United States Patent and Trademark Office

APPLICATION NO.	FILING DATE	FIRST NAMED INVENTOR	ATTORNEY DOCKET NO.	CONFIRMATION NO.		
10/613,494 07/01/2003		Jun-Young Lee	50391/DBP/Y35	4433		
23363	7590 07/26/2006		EXAM	EXAMINER		
CHRISTIE	, PARKER & HALE, LLP	MOON, SEOKYUN				
PO BOX 700 PASADENA	68 A, CA 91109-7068	ART UNIT	PAPER NUMBER			
	,		2629			
			DATE MAILED: 07/26/2006

DETAILED ACTION

a first signal line coupled to a common contact between the first switch and the second switch [drawing 1 provided below, which is equivalent to Kishi's fig. 62]; and

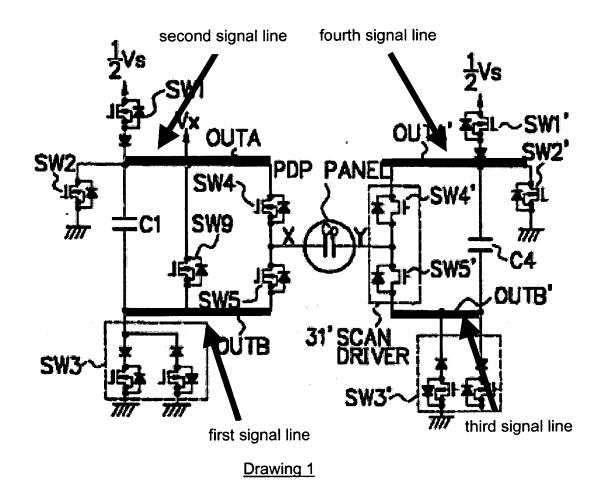
As to claim 7, Kishi [fig. 62] teaches an apparatus for driving a plasma display panel, which has a panel capacitor ("Co"), the apparatus comprising:

a first switch ("SW5") and a second switch ("SW3") being coupled in series between a first power source ("ground") for supplying a first voltage ("0") and a first terminal of the panel capacitor;

a third switch ("SW4") and a fourth switch ("SW1") being coupled in series between the first terminal of the panel capacitor and a second power source ("1/2Vs") for supplying a second voltage;

a second signal line coupled to a common contact between the third switch and the fourth switch,

wherein a voltage between the first signal line and the second signal line is a third voltage ("1/2Vs"), the first voltage and the second voltage are alternatively applied to the first terminal of the panel capacitor, and

wherein a ground voltage is applied to the first signal line while the second voltage ("1/2Vs") is applied to the first terminal of the panel capacitor.

a third signal line coupled to a common contact between the fifth switch and the sixth switch [drawing 1 provided on page 5 of this office action]; and

As to **claim 15**, Kishi [fig. 62] [drawing 1 provided on page 5 of this office action] teaches a method for driving a plasma display panel, by alternatively applying a first voltage ("1/2Vs") and a second voltage ("ground") respectively through a first signal line and a second signal line both coupled to a first terminal ("X") of a panel capacitor ("Co"), a first common contact being formed between a first switch and a second switch located between a third switch and a fourth switch located on the second signal line, the method comprising:
